**Proposed Rezoning of the “Comprehensive Development Area (1)” Site to
“Residential (Group B)13”, “Residential (Group B)14” and “Recreation”
and Amendment to the Building Height Restriction of the “Government,
Institution or Community” Site from 2 storeys to 8 storeys for Residential
Development(s) with Retail, Public Vehicle Park and Social Welfare Facilities
Various Lots in D.D. 11 and Adjoining Government Land,
Fung Yuen, Tai Po, New Territories**

(Section 12A Amendment of Plan Application No. Y/TP/40)

- Further Information No. 3 -

Figure 2 Potential site for NTEH development within the proposed R(B) 14 zone

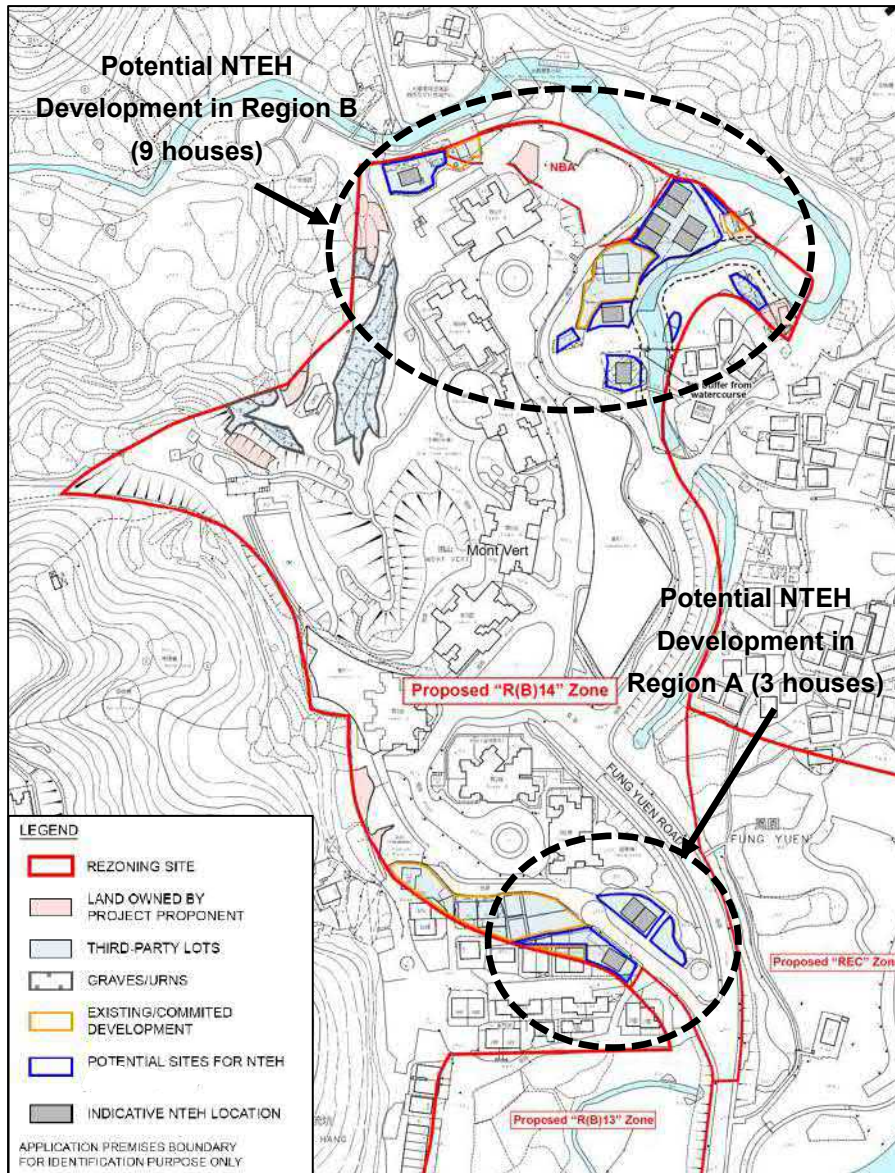
3.2	Para. 4.3 and Para. 1.3.1 in Appendix 2 refer. Existing site photos should be included in order to substantiate the Applicant's statement.	Figure 3 is added into Para. 1.3.1 of Appendix 2 for the sensitivity test to show the existing land use of the potential sites of NTEH.

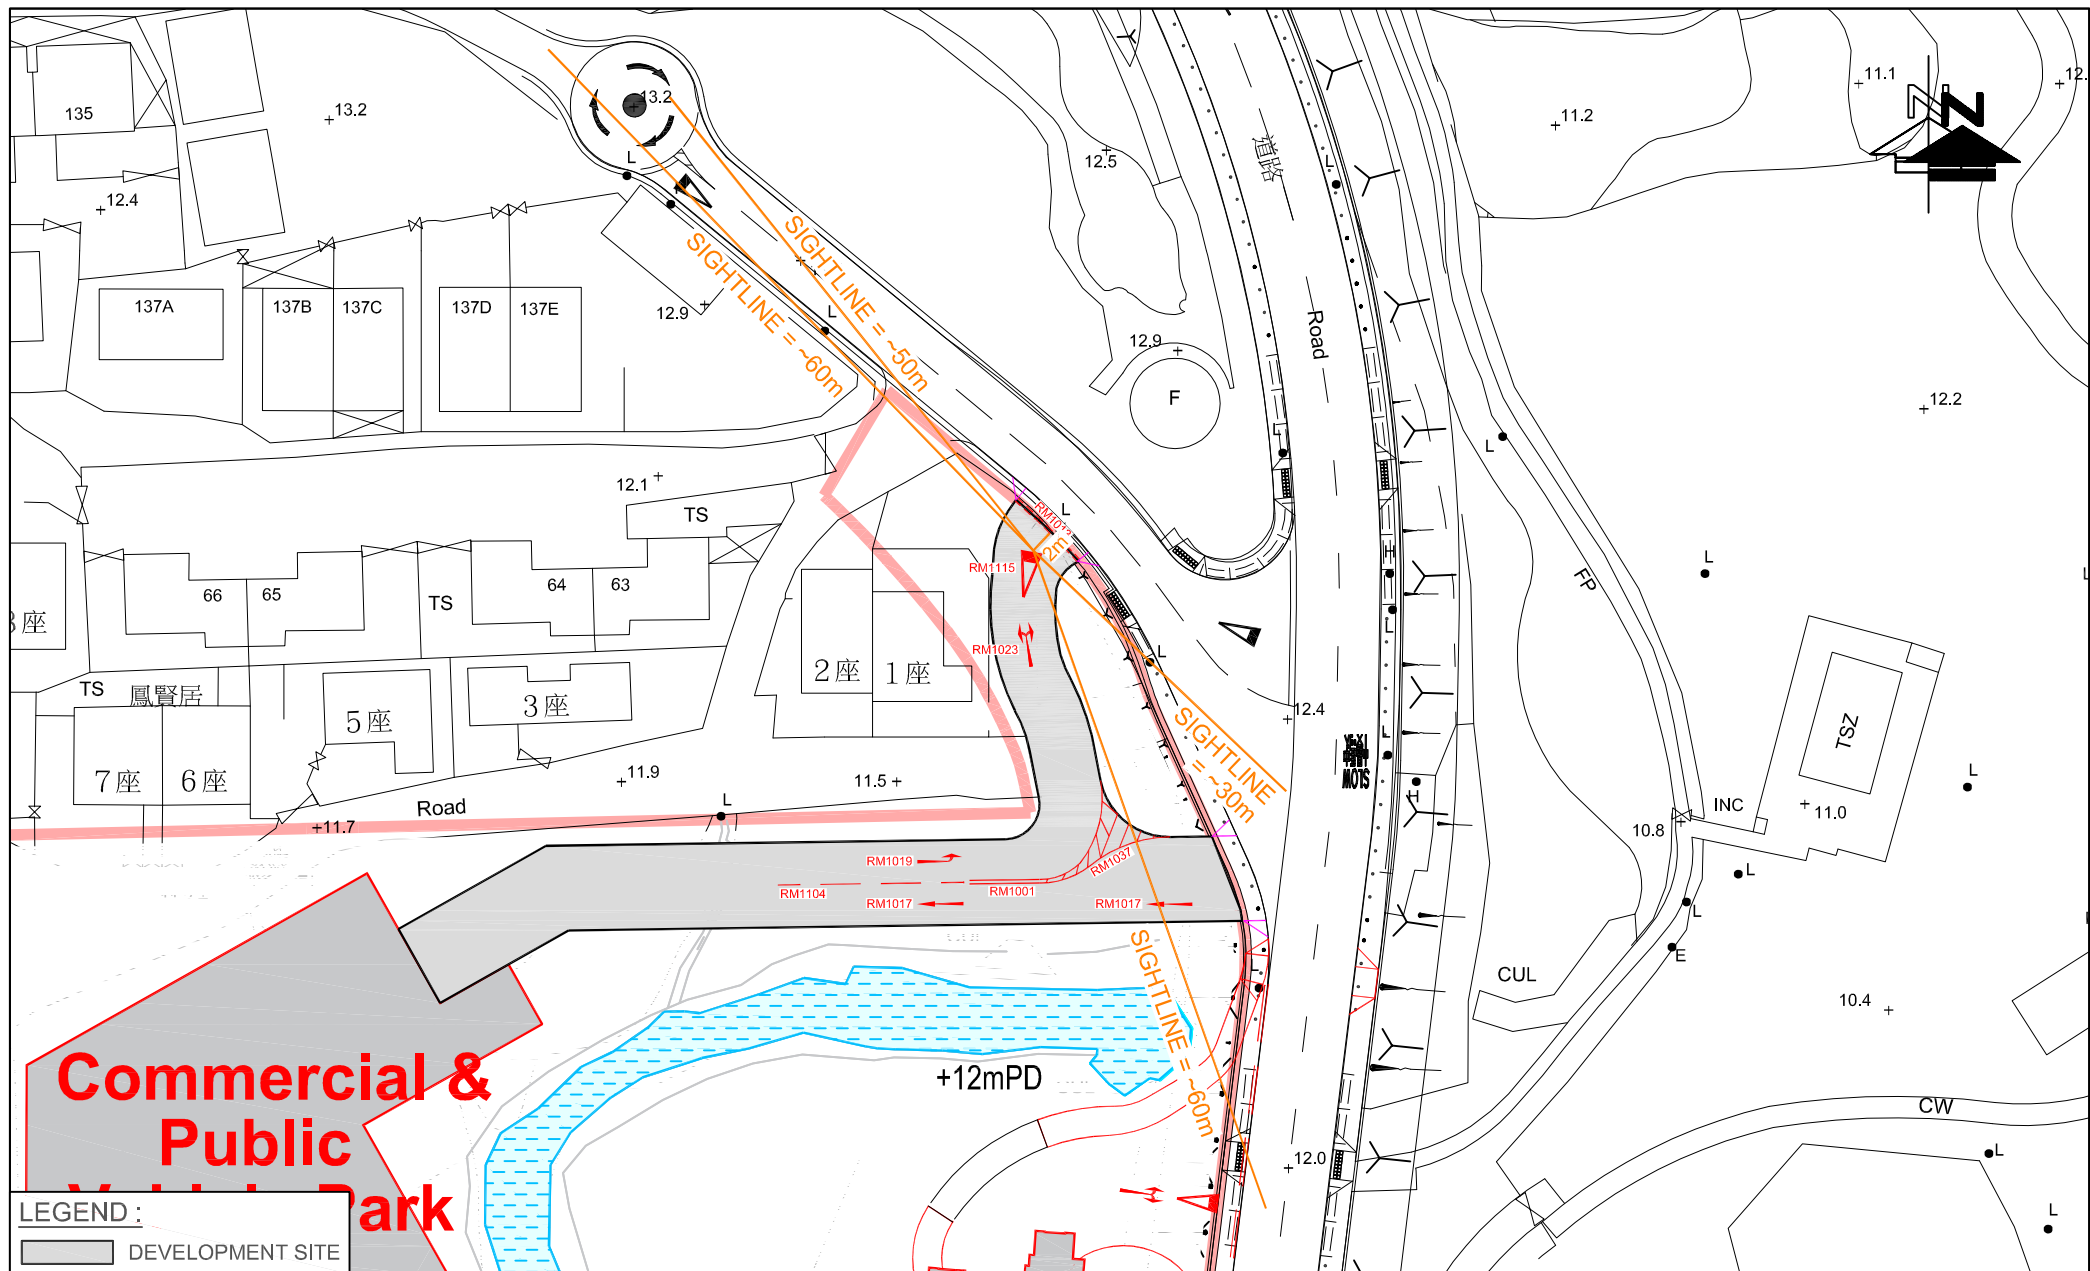
12.1	RtoC 8.3 - The sightline assessment shall comply with TPDM Vol 2 Ch 3.6.3.2 and Diagram 3.6.3.4. No objects, including structures, plants, etc. shall be placed obstructing the sightline.	As shown in Figures 2.3 (SL), 2.4 (SL) and 2.5 (SL) in Annex B , sight distance of 60m could be maintained which comply with TPDM requirement. No objects, including structures, plants, etc. will be placed obstructing the sightline.

12.3	Figure 2.3(SL) - The sight distance to the right of the vehicle egress is only 30m. Please demonstrate the sight distance complies with TPDM requirement.	30m is the distance between the development run-out and the Fung Yuen Road. Sightlines of 60m are also added to Figure 2.3 (SL) in Annex B . The sight distance complies with TPDM requirement.

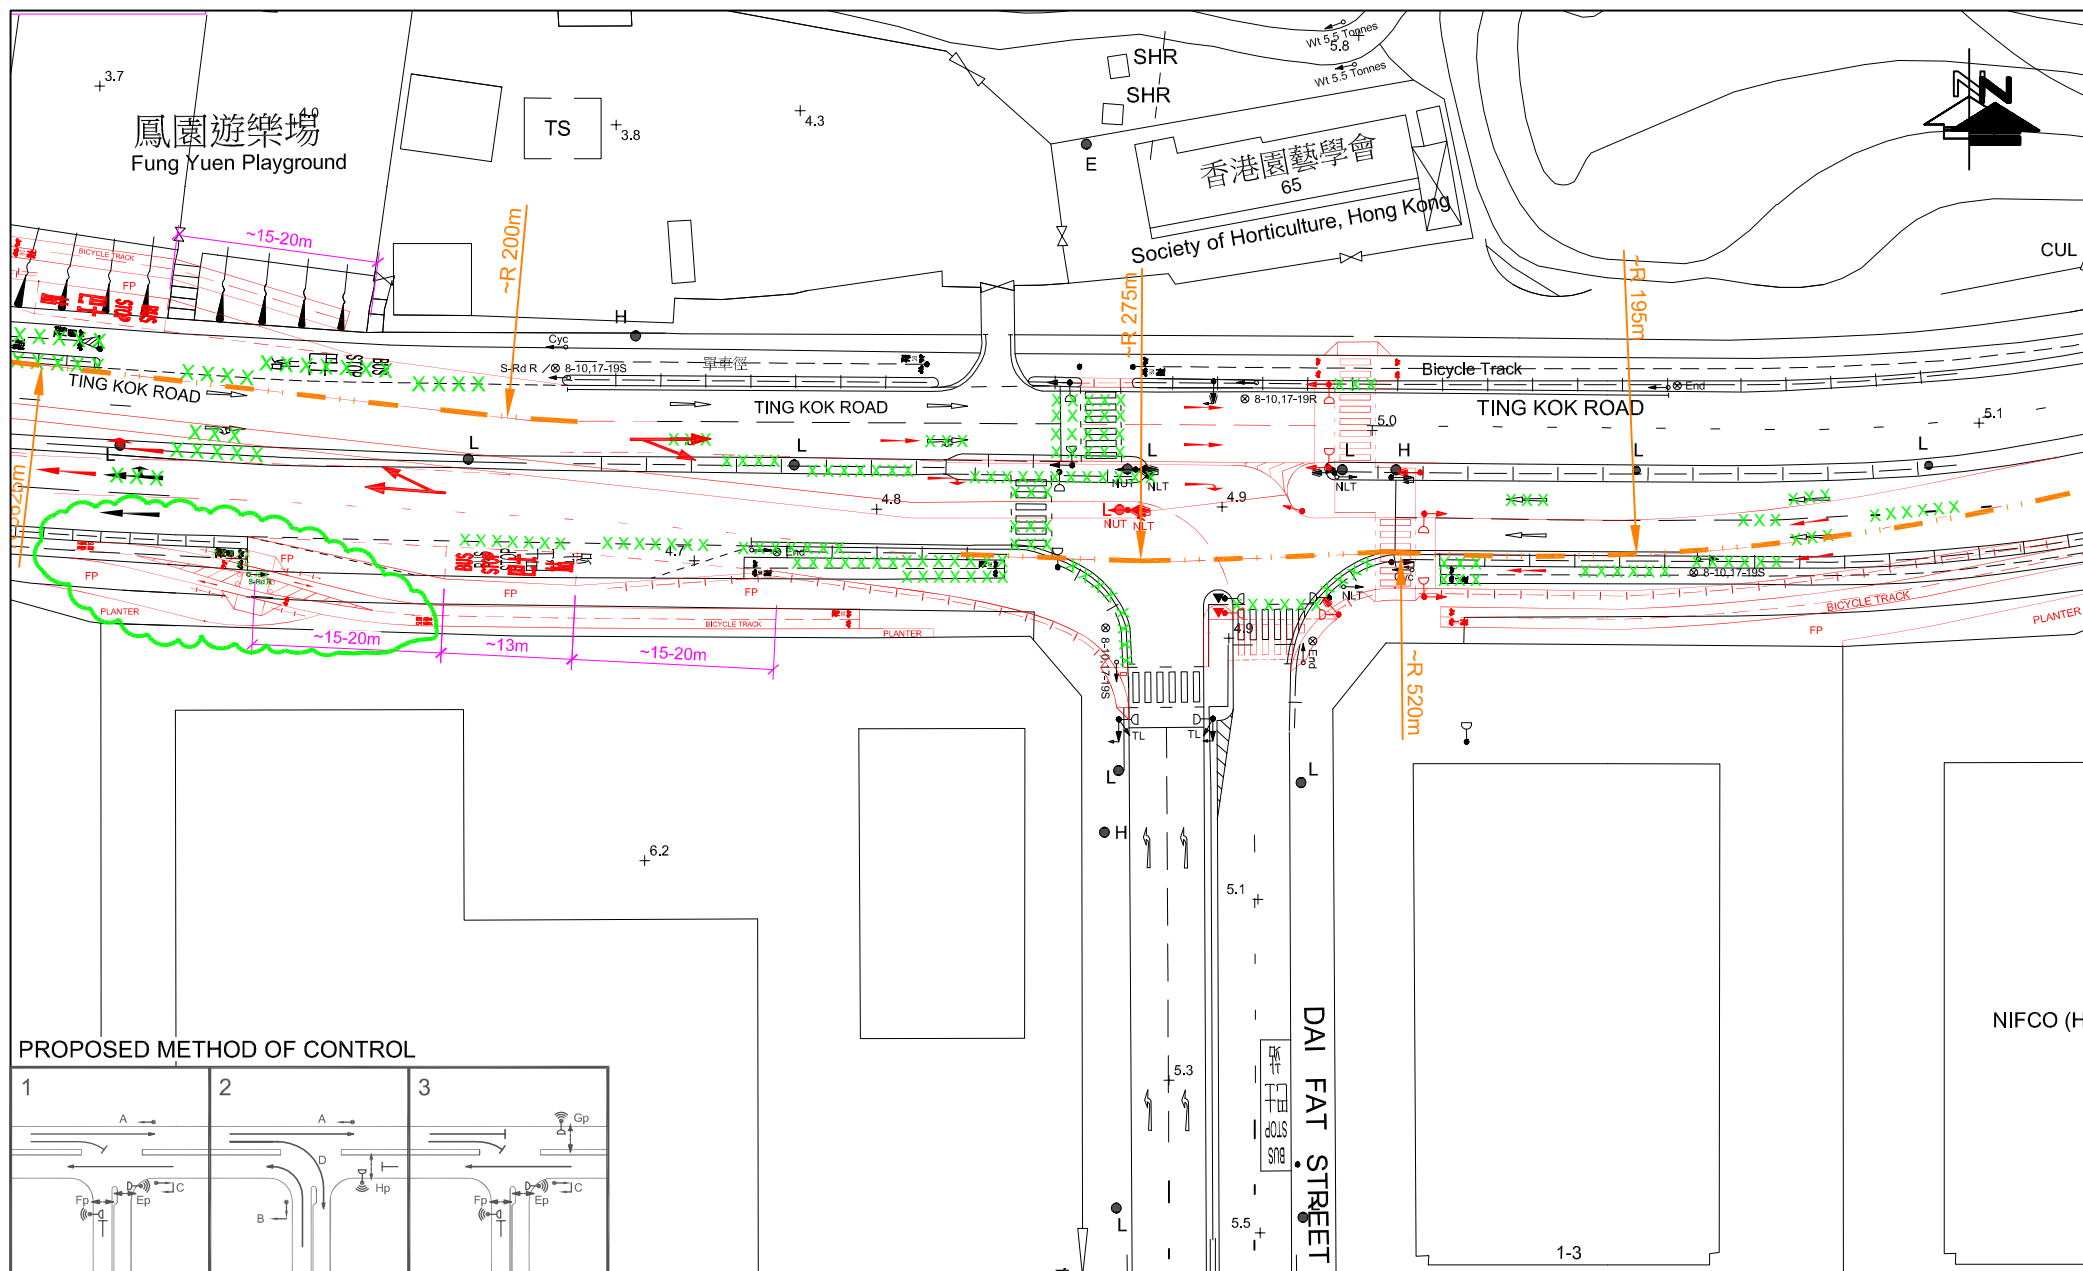
12.7	RtoC 8.9 - Figure 4.4 - Please review the sharp bends at cycle track near the pedestrian crossing.	The cycle track is revised as shown in Figure 4.4 in Annex B . The connectivity of cycle track could be maintained and the potential conflict between pedestrian and cyclists are minimised.
